## **PMLevyCOLPEm Resource**

**From:** Habib, Donald  
**Sent:** Wednesday, June 20, 2012 8:48 AM  
**To:** maryo@nirs.org  
**Subject:** FW: Draft LNP RAI response - Seismic Evaluation  
**Attachments:** RAI L-0998 Response Outline 06-18-12.pdf

## NRC RAI

## Response L-0998 Outline:

Figure RAI L-0998-1: Comparison of hard rock UHRS based on the EPRI-SOG/UCSS model from FSAR with hard rock UHRS using CEUS SSC model.

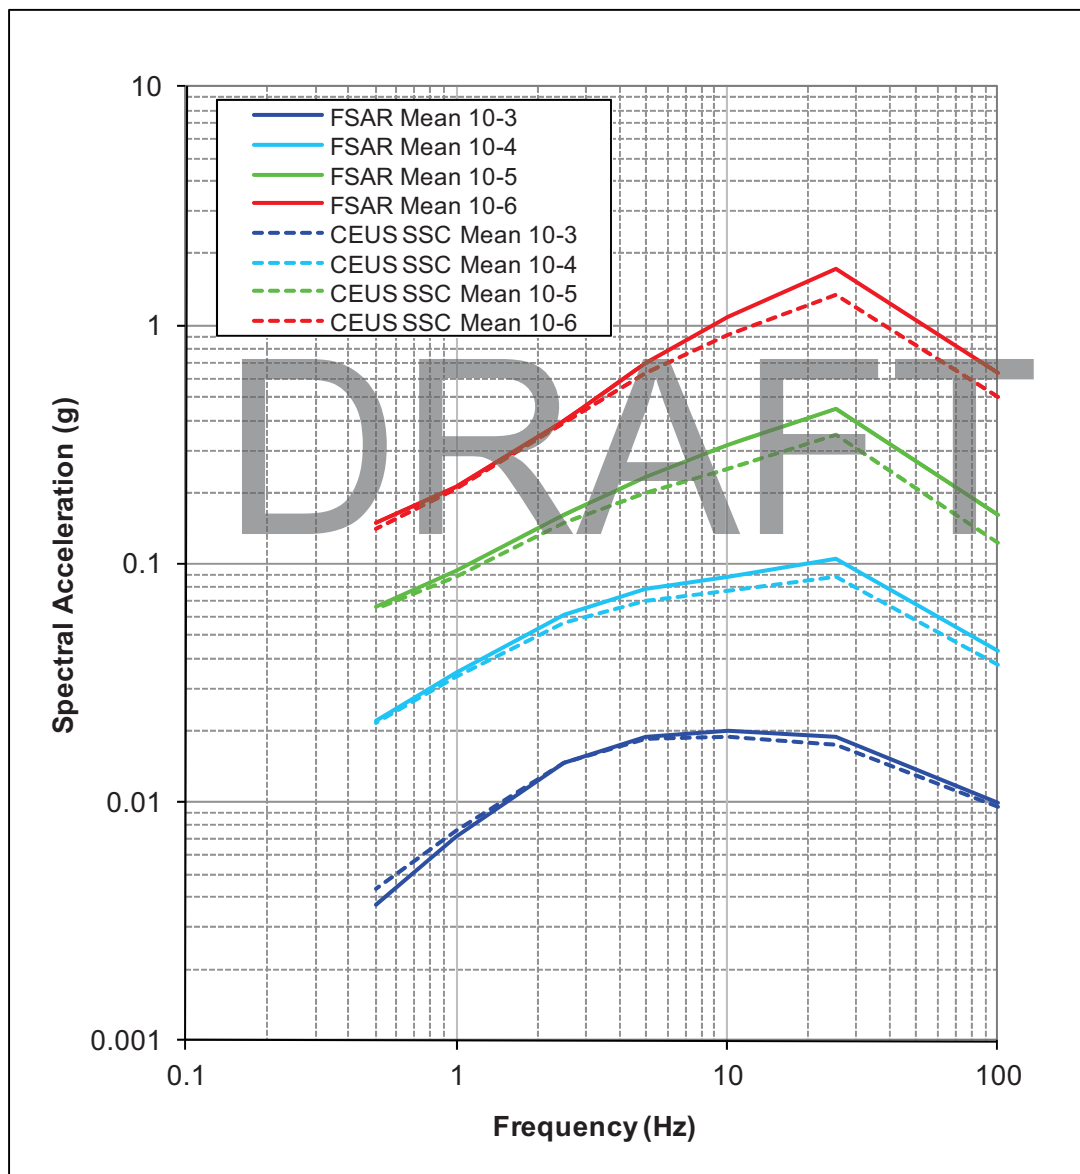
Figure RAI L-0998-1 compares the hard rock UHRS based on the EPRI-SOG/UCSS source model used in the FSAR to the hard rock UHRS based on the CEUS SSC source model. The rock UHRS based on the CEUS SSC model are somewhat lower at spectral frequencies above 2.5 Hz and are similar to the Calculation LNP-0000-X7C-031 results for lower spectral frequencies. The only place where the CEUS SSC model produces higher motions is for the  $10^{-3}$  UHRS at low frequencies. This higher hazard is likely due to the larger maximum magnitudes for the distributed seismicity sources in the CEUS SSC model.

Figure RAI L-0998-2: Comparison of scaled GMRS based on EPRI-SOG/UCSS model with full CAV with the GMRS based on the CEUS SSC model with modified CAV

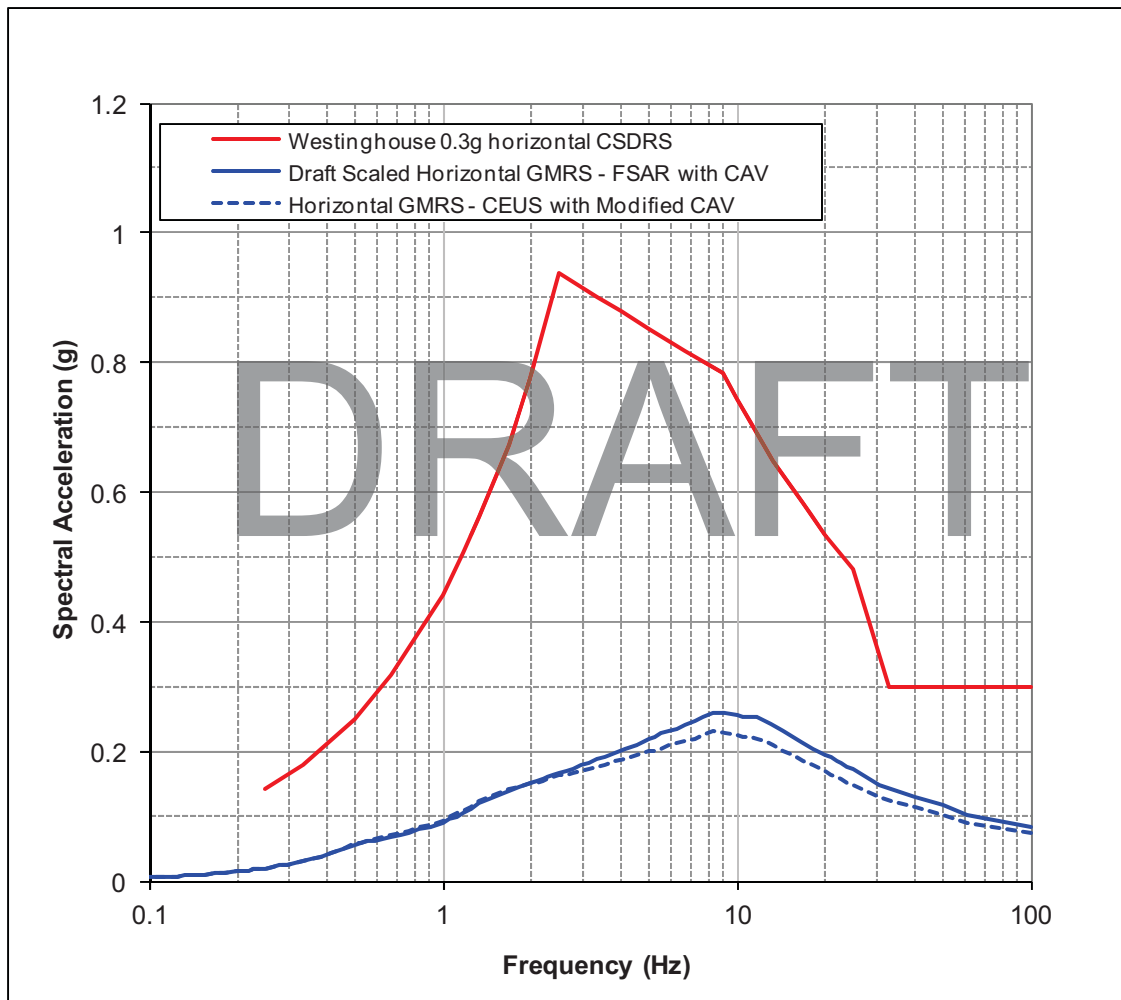
As shown in Figures RAI L-0998-2 and RAI L-0998-3, both the CEUS SSC GMRS and the PBSRS are enveloped by the AP1000 CSDRS. As discussed above, the CEUS SSC LNP site specific floor response spectra (FRS) at the six key locations are bounded by the CSDRS FRS and the maximum bearing pressure is less than the 24 ksf design value. Thus, LNP site unique foundation conditions and CEUS SSC ground motions do not lower the High Confidence Low Probability of Failure (HCLPF) values calculated for the certified design.

Figure RAI L-0998-2 compare the scaled GMRS based on the EPRI-SOG/UCSS model with full CAV with the GMRS based on the CEUS SSC model with modified CAV. The scaled GMRS based on the CEUS SSC is lower than the GMRS based on the EPRI-SOG/UCSS model with full CAV except for frequencies between 0.2 and 2 Hz where the maximum increase is approximately 4 percent at 1 Hz.

Figure RAI L-0998-3: Comparison of PBSRS based on EPRI-SOG/UCSS model with full CAV with the PBSRS based on the CEUS SSC model with modified CAV

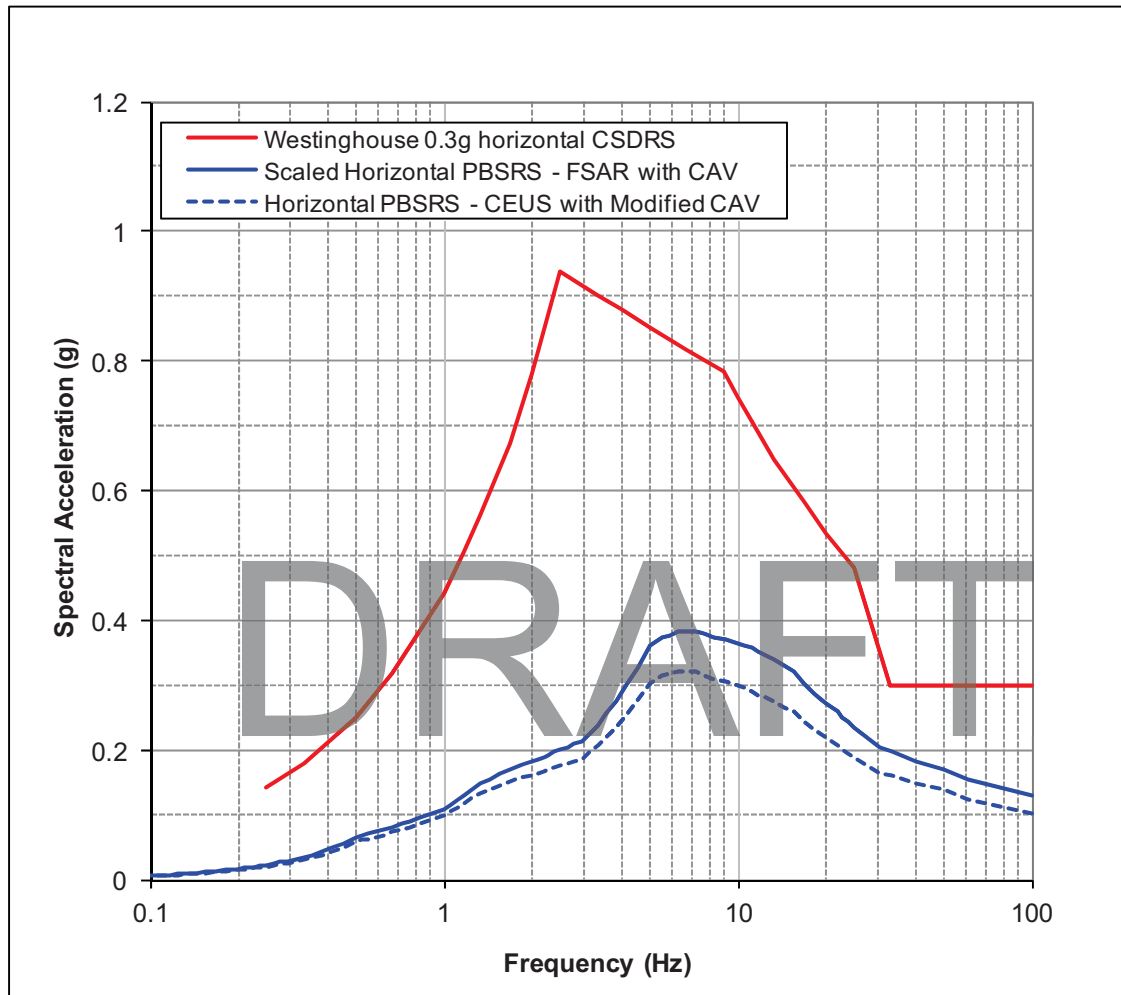
The EPRI SOG scaled finished grade PBSRS was used to show that there is no interaction between the adjacent AB, TB, and RB with the NI. As shown in Figure RAI L-0998-3, the CEUS SSC finished grade PBSRS is enveloped by the EPRI SOG scaled finished grade PBSRS. Thus, the conclusions that there is no interaction between the adjacent AB, TB, and RB with the NI is valid for the LNP site ground motions based on the CEUS SSC model.

Figure RAI L-0998-3 compares the scaled PBSRS based on the EPRI-SOG/UCSS model with full CAV with the PBSRS based on the CEUS SSC model with modified CAV. The PBSRS based on the CEUS SSC model is enveloped by the scaled PBSRS based on the EPRI-SOG/UCSS model at all frequencies,

adjacent AB, TB, and RB, earthquake induced cyclic stresses in the soil column were based on ground motions consistent with the finished grade scaled PBSRS. As shown in Figure RAI L-0998-3, the CEUS SSC PBSRS is enveloped by the EPRI SOG scaled PBSRS. Thus, the liquefaction evaluations based on the EPRI SOG LNP ground motions bound those from the CEUS SSC ground motions.

As shown in Figure RAI L-0998-3, the CEUS SSC PBSRS is enveloped by the EPRI SOG scaled PBSRS used for site specific displacement of the Annex Building, Turbine Building, and the Radwaste Building as described in Subsections 3.7.2.8.1, 3.7.2.8.2, and 3.7.2.8.3. Thus the conclusions in these subsections of no seismic interaction between the Annex Building, Turbine Building, and Radwaste Building and the NI is valid for the LNP site ground motions based on the CEUS SSC model.

Figure RAI L-0998-4: Comparison of  $10^{-5}$  surface UHRS based on EPRI-SOG/UCSS model with full CAV with the  $10^{-5}$  surface UHRS based on the CEUS SSC model with modified CAV.

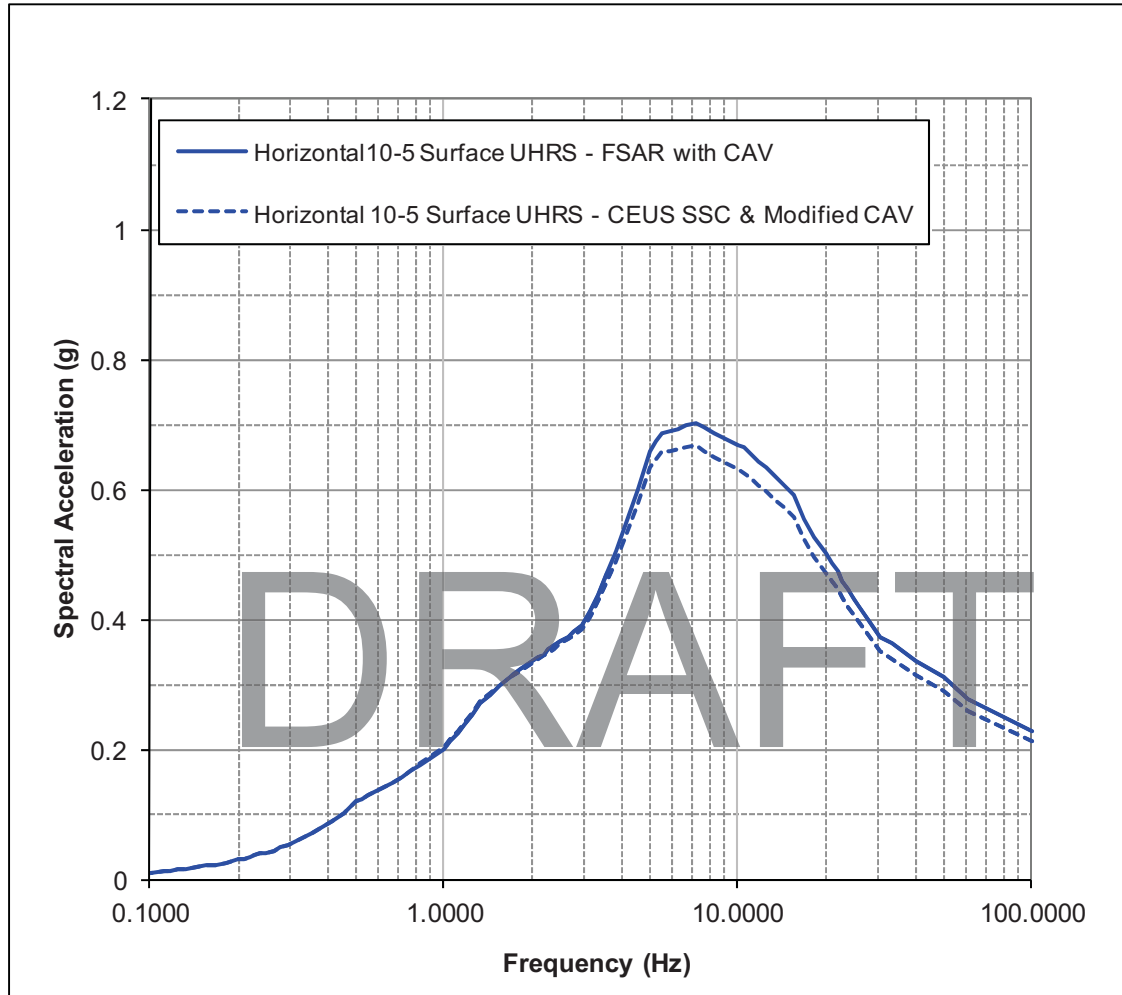
Figure RAI L-0998-4 compares the  $10^{-5}$  UHRS based on the EPRI-SOG/UCSS model with full CAV with the  $10^{-5}$  UHRS based on the CEUS SSC model with modified CAV. The  $10^{-5}$  UHRS based on the CEUS SSC model is enveloped by the scaled  $10^{-5}$  UHRS based on the EPRI-SOG/UCSS model at all frequencies except in the frequency range of 0.5 to 1.7 Hz where the  $10^{-5}$  UHRS based on the CEUS SSC model is up to 1.7 percent higher.

Figure RAI L-0998-5: Comparison of RB FIRS (+11 ft) based on EPRI-SOG/UCSS model with full CAV with the RB FIRS based on the CEUS SSC model with modified CAV

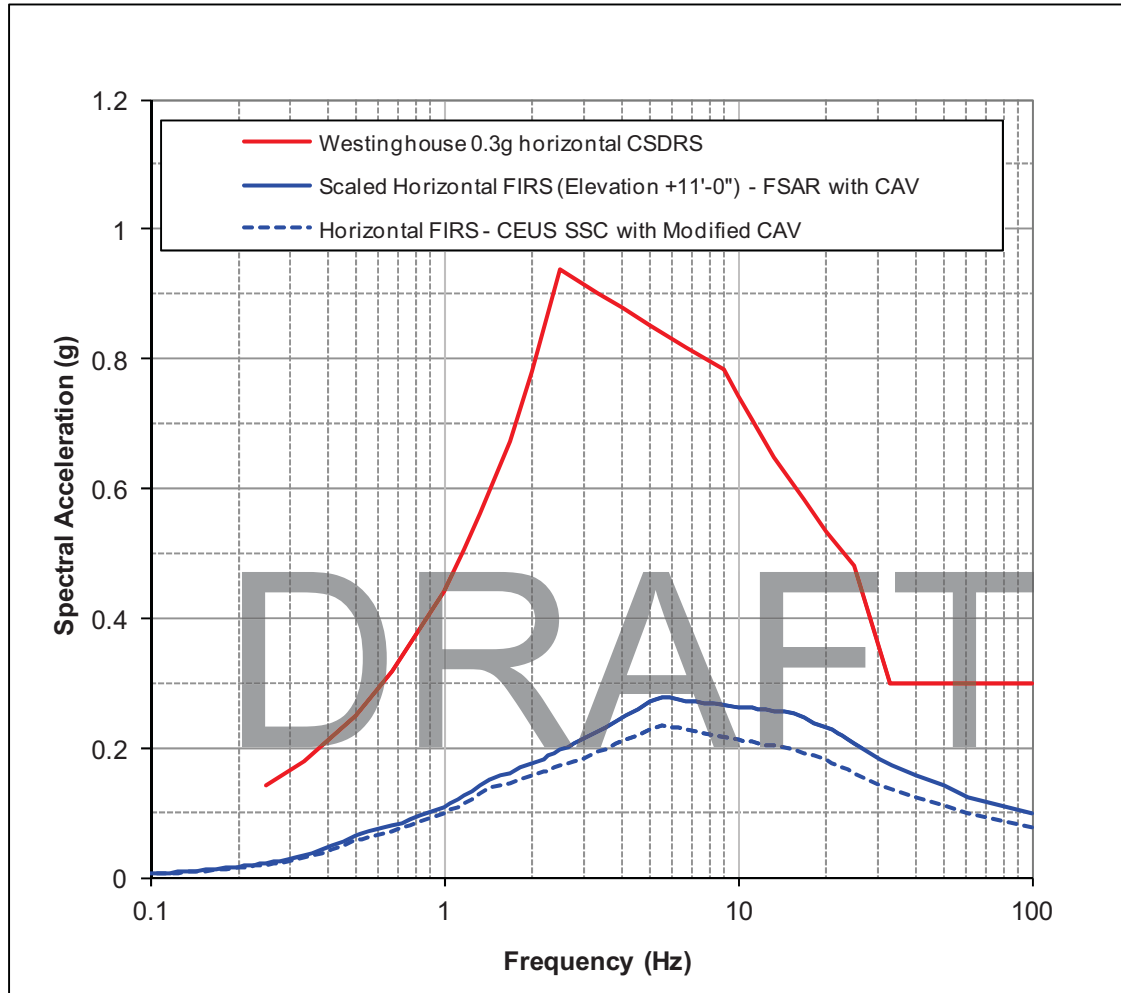
The scaled EPRI SOG scaled FIRS (EL +11 ft.) was the input ground motion for the LNP site specific SSI analysis. As shown in Figure RAI L-0998-5, the CEUS SSC FIRS (EL +11 ft.) is enveloped by the EPRI SOG scaled FIRS (EL +11 ft.). Thus, the conclusions of the LNP site specific SSI analysis that the LNP floor response spectra (FRS) at the six key locations are bounded by the CSDRS FRS and the maximum bearing pressure is less than the 24 ksf design value are also valid for the for the LNP site ground motions based on the CEUS SSC model.

Figure RAI L-0998-5 compares the scaled Reactor Building FIRS based on the EPRI-SOG/UCSS model with full CAV with the Reactor Building FIRS based on the CEUS SSC model with modified CAV. The Reactor Building FIRS based on the CEUS SSC model is enveloped by the scaled Reactor Building FIRS based on the EPRI-SOG/UCSS model at all frequencies.

As shown in Figure RAI L-0998-5, the CEUS SSC FIRS is enveloped by the EPRI SOG scaled FIRS used for site specific soil structure interaction analysis described in Subsection 3.7.2.4.1. Because the CEUS SSC vertical FIRS scales directly with the CEUS SSC horizontal FIRS and the V/H ratios are unaffected, the CEUS SSC FIRS will also be enveloped by the scaled EPRI SOG vertical FIRS. Thus, the conclusions of the soil structure analysis presented in Subsections 3.7.2.4.1.5 and 3.7.2.4.1.6 are valid for the LNP site ground motions based on the CEUS SSC model.

Figure RAI L-0998-6: Comparison of the horizontal  $10^{-5}$  UHRS at finished grade developed using the EPRI-SOG/UCSS source model presented in the FSAR with 1.67 x the GMRS developed using the CEUS SSC model with modified CAV.

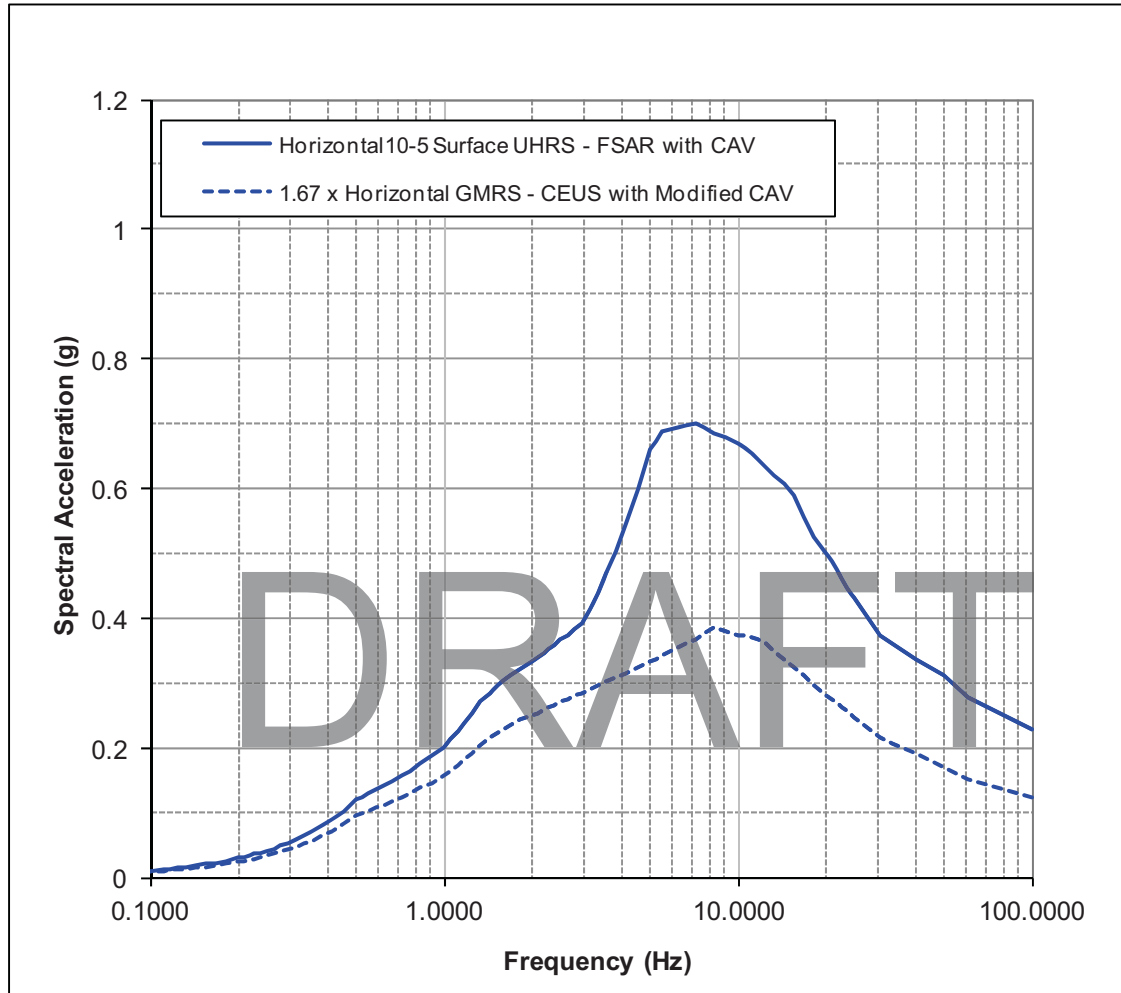
To evaluate the HCLPF liquefaction potential of soils under the adjacent AB, TB, and RB, earthquake induced cyclic stresses in the soil column based on ground motions consistent with the EPRI SOG finished grade  $10^{-5}$  UHRS were used. As shown in Figures RAI L-0998-6 and RAI L-0998-7, 1.67\*GMRS and 1.67\*PBSRS developed using the CEUS SSC methodology and modified CAV filter are enveloped by the EPRI SOG finished grade  $10^{-5}$  UHRS. Thus, HCLPF capacity for no liquefaction potential of soil under the AB, TB, and RB exceeds the 1.67\*GMRS goal for the plant level HCLPF for the CEUS SSC ground motions.

To calculate the HCLPF capacity for seismic interaction between the AB, TB, and RB and the NI, the AB, TB, and RB displacements relative to the NI were calculated using the EPRI SOG finished grade  $10^{-5}$  UHRS. As shown in Figures RAI L-0998-6 and RAI L-0998-7, 1.67\*GMRS and 1.67\*PBSRS developed using the CEUS SSC methodology and modified CAV filter are enveloped by the EPRI SOG finished grade  $10^{-5}$  UHRS. Thus, HCLPF capacity for no seismic interaction between the AB, TB, and RB and the NI exceeds the 1.67\*GMRS goal for the plant level HCLPF for the CEUS SSC ground motions.

Figures RAI L-0998-6 and -7 compare the  $10^{-5}$  horizontal surface UHRS based on the EPRI-SOG/UCSS model with full CAV to 1.67 x the GMRS and PBSRS, respectively, based on the CEUS SSC model with modified CAV. The 1.67 x the GMRS and PBSRS based on the CEUS SSC model with modified CAV are enveloped by the  $10^{-5}$  horizontal surface UHRS based on the EPRI-SOG/UCSS model with full CAV.
